PROPOSED REVISION 15
AP1000 DESIGN CONTROL DOCUMENT

Tier 1 Subsection 2.2.2; Tables 2.2.2-1, 2.2.2-2, and 2.2.2-3; and Figure 2.2.2-1
Passive Containment Cooling System

Provide clarifications and corrections to Tier 1 subsection 2.2.2.

Figure 2.2.2-1
Passive Containment Cooling System

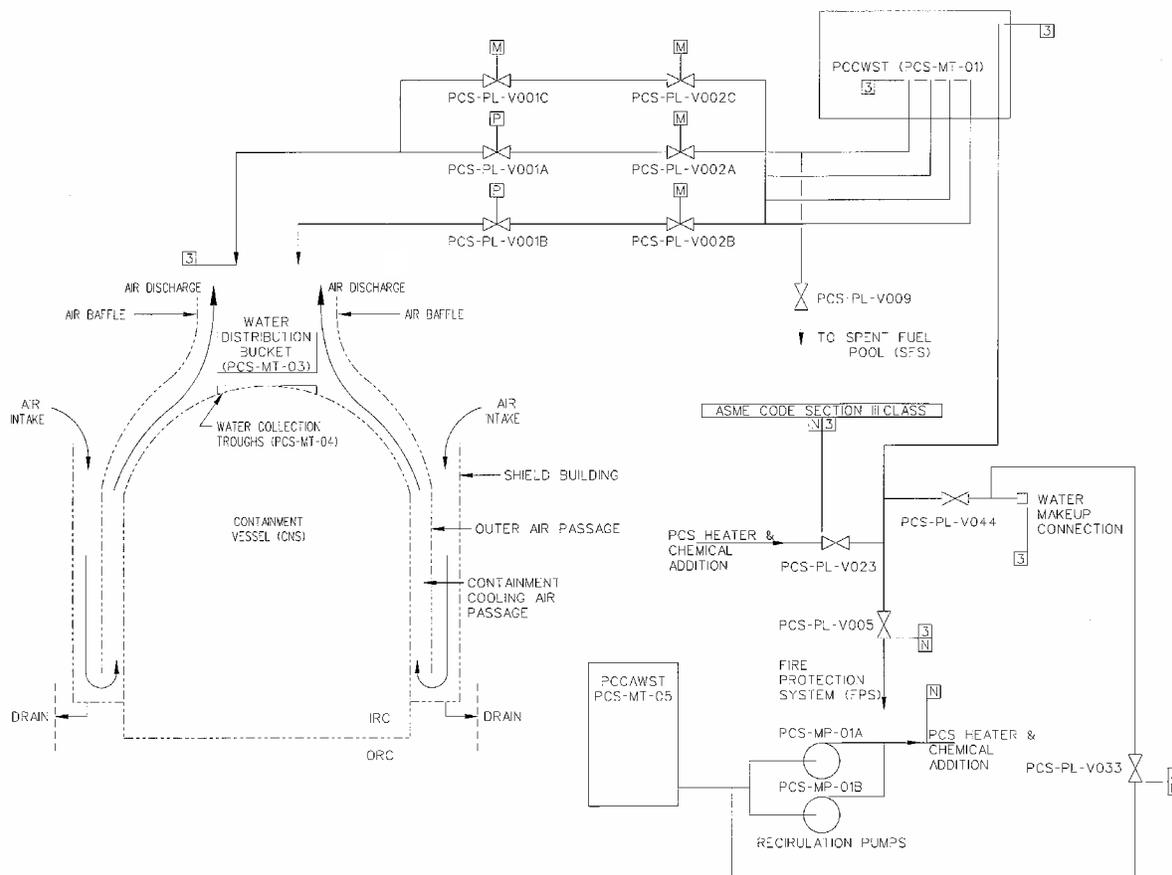
4. In Table 2.2.2-1, replace water makeup stop check valve PCS-PL-V014A with water makeup isolation valve PCS-PL-044, in order to agree with the AP1000 P&ID, APP-PCS-M6-001, Revision 0. This valve is a normally closed, manual valve.

5. Add pipeline PCS-PL-005 to Table 2.2.2-2. This is the third PCCWST discharge line with a diverse, motor-operated, isolation valve.
6. Table 2.2.2-3, item 7.a), i; revise the Inspections, Tests, and Analyses entry and the Acceptance Criteria entry to state that “each one of three parallel paths” is to be tested, and meets the stated criteria.

Tier 1 Figure 2.2.2-1 Revise Tier 1 Figure 2.2.2-1 as shown on the following page.
